Mercedes-Benz

Campaign No. 2022070006, August 2022

SUBJECT: **Model GLS-Class (167 platform)**
Model Year 2020

Repair Upfront Airbag Sensor Wiring Harness Routing

Figure 1

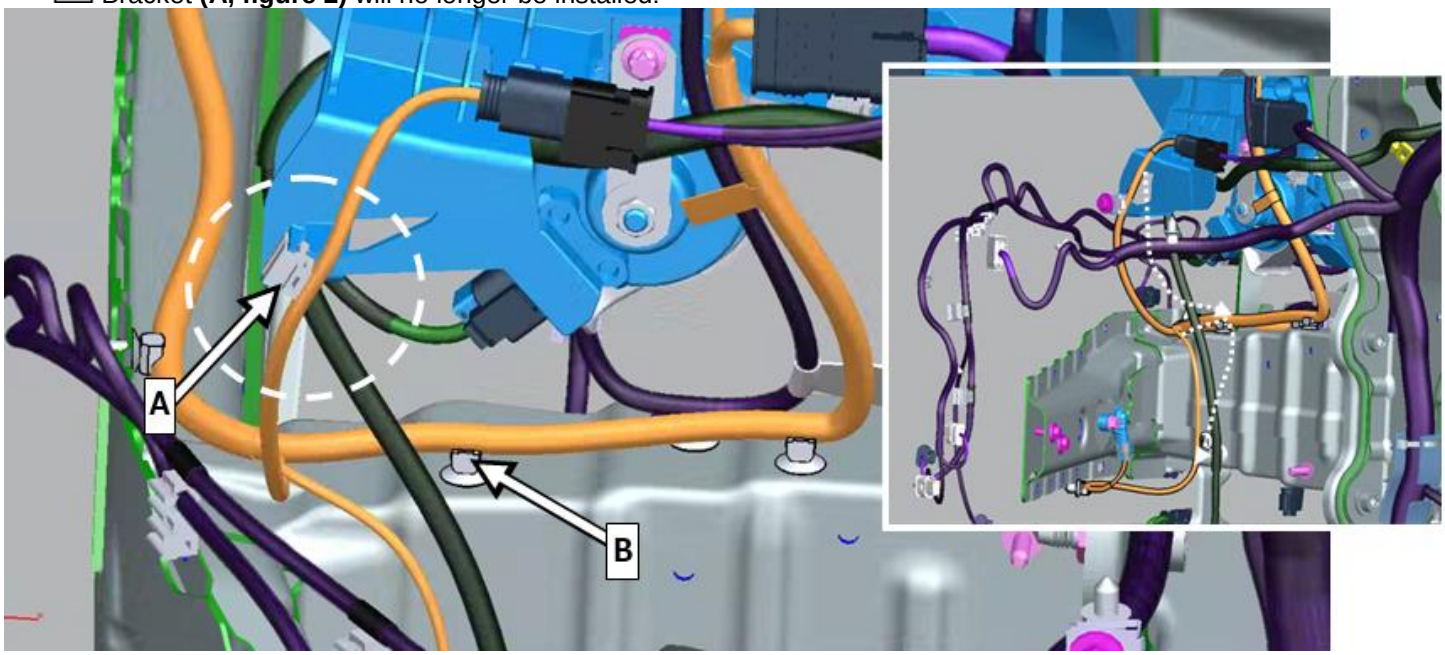
1. Remove front section from the front left fender liner.
i For basic data, see AR88.10-P-1301ME.

Figure 3

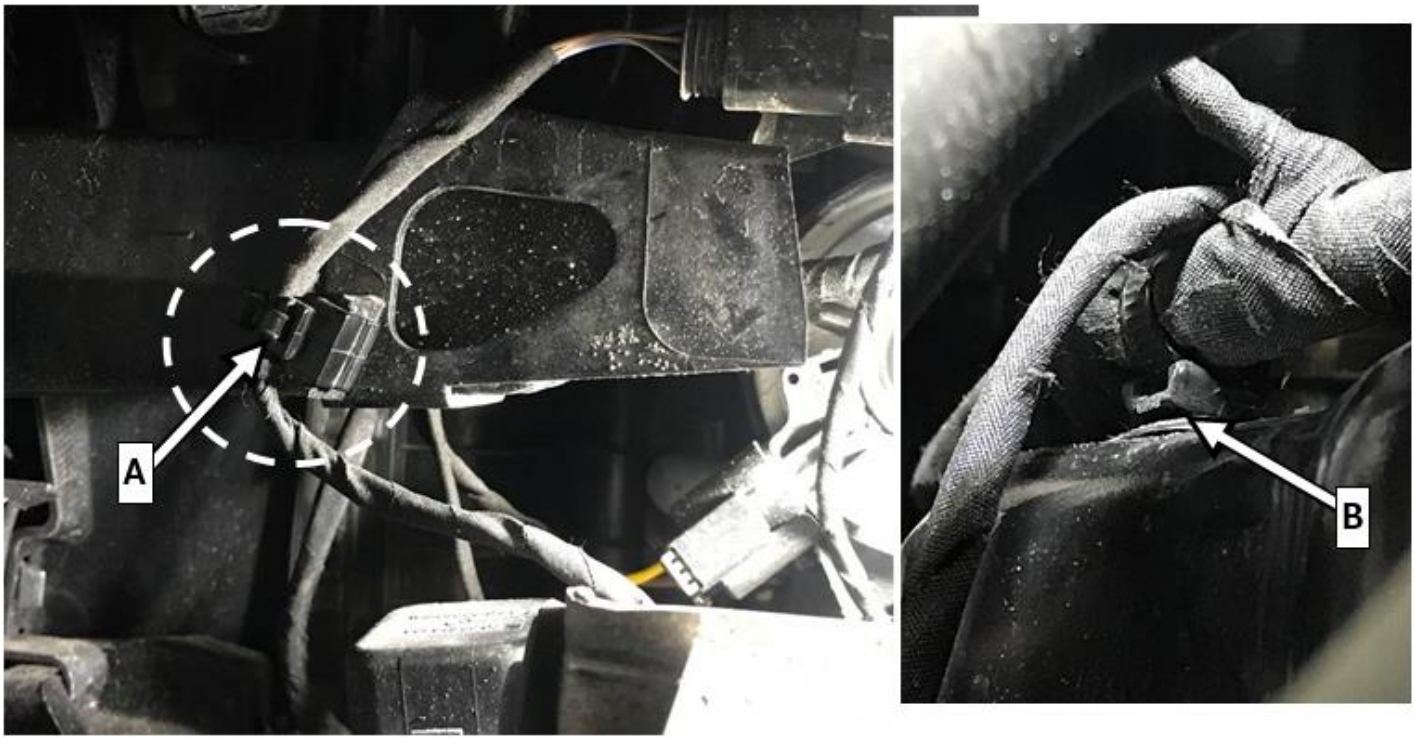
3. Route wiring harness according to figure 4 and fasten with new cable tie to bracket **(B, figure 4)**.

Figure 2

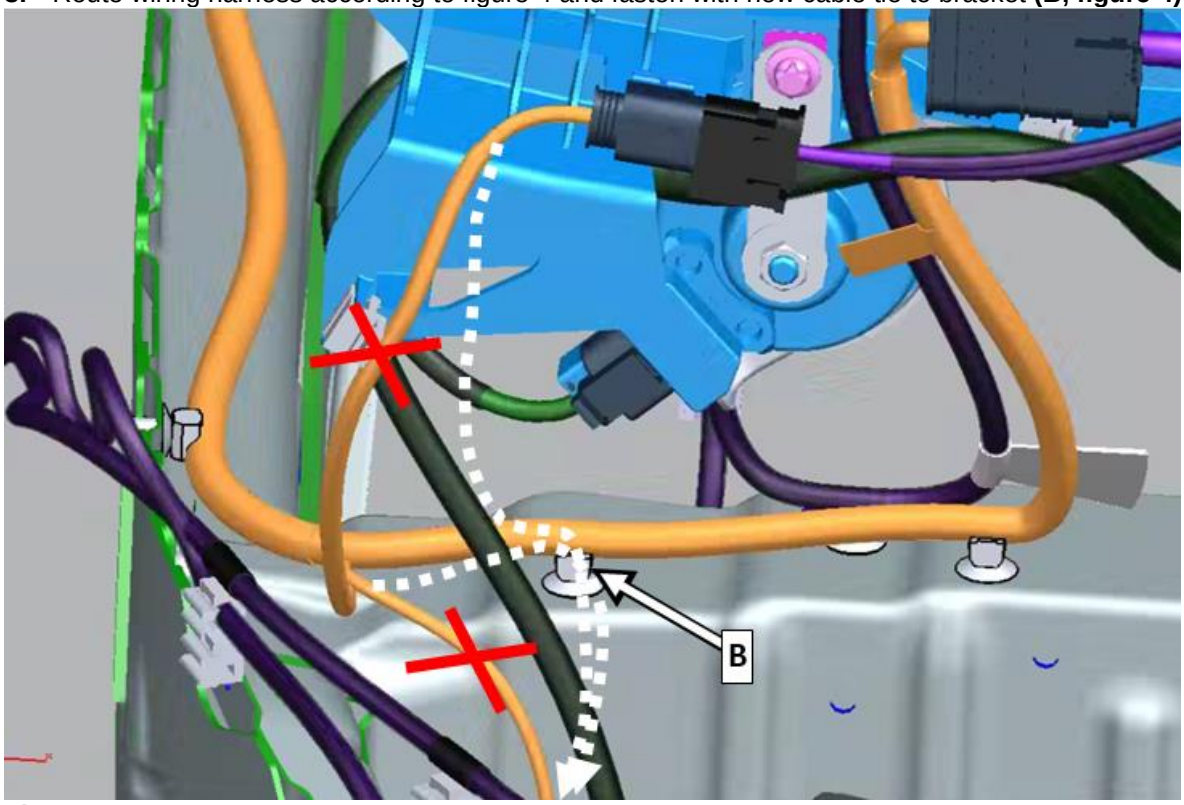
2. Remove bracket **(A, figure 2)** including cable tie from wiring harness and remove cable tie on bracket **(B, figure 2)** on upper left longitudinal member.

i Bracket **(A, figure 2)** will no longer be installed!
